**KENYA CIVIL AVIATION AUTHORITY**

**FIRST CLARIFICATION FOR TENDER FOR SUPPLY, DELIVERY, INSTALLATION, TRAINING AND COMMISSIONING OF 3D PANORAMIC TOWER, APPROACH AND AREA AIR TRAFFIC CONTROL TRAINING SIMULATOR AT EAST AFRICAN SCHOOL OF AVIATION : TENDER NUMBER KCAA/016/2024-2025:**

**RESPONSE TO THE REQUEST FOR CLARIFICATIONS TO THE TENDER FOR THE SUPPLY, DELIVERY, INSTALLATION, TRAINING AND COMMISSIONING OF 3D PANORAMIC TOWER, APPROACH AND AREA AIR TRAFFIC CONTROL TRAINING SIMULATOR AT EAST AFRICAN SCHOOL OF AVIATION AS AT WEDNESDAY, 5<sup>TH</sup> FEBRUARY 2025: TENDER NUMBER KCAA/016/2024-2025.**

# ANNEX III

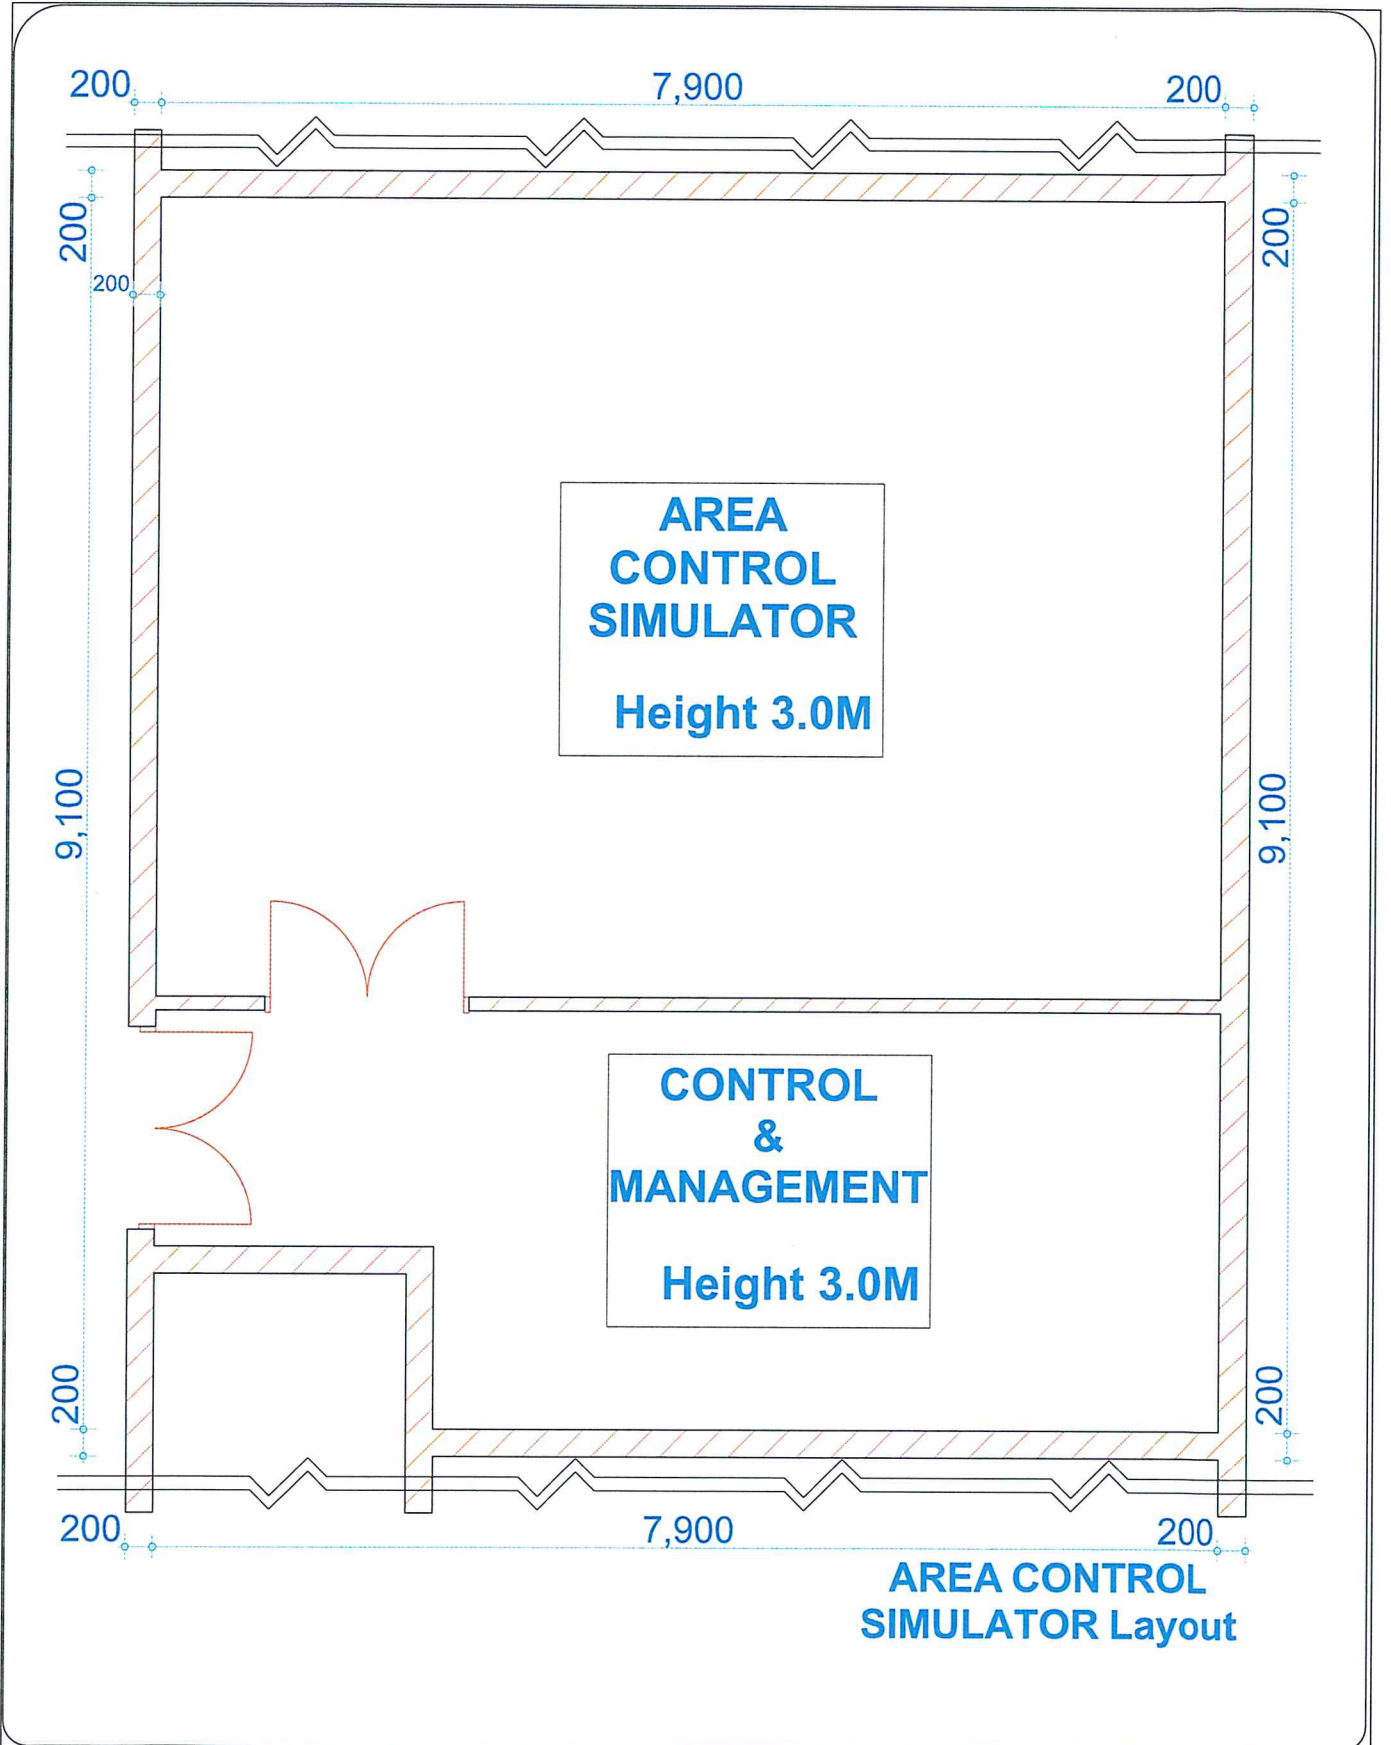
17.	<p>The Procuring entity should provide measurements of the halls where the simulators will be installed, the floor in terms of length and width, and height of the hall.</p>	<p>Area Simulator and Tower &amp; Approach Simulator floor layouts are attached. These layouts for the rooms has provided approximate measurements and it is the responsibility of the bidder to establish and confirm exact measurements.</p>

<b>No.</b>	<b>Clarifications Sought</b>	<b>KCAA's response to the clarifications.</b>
20.	Please provide diagrams of the rooms / floor where the simulators will be installed, including exact dimensions and distances between rooms.	Area Simulator and Tower & Approach Simulator floor layouts are attached. These layouts for the rooms has provided approximate measurements and it is the responsibility of the bidder to establish and confirm exact measurements.
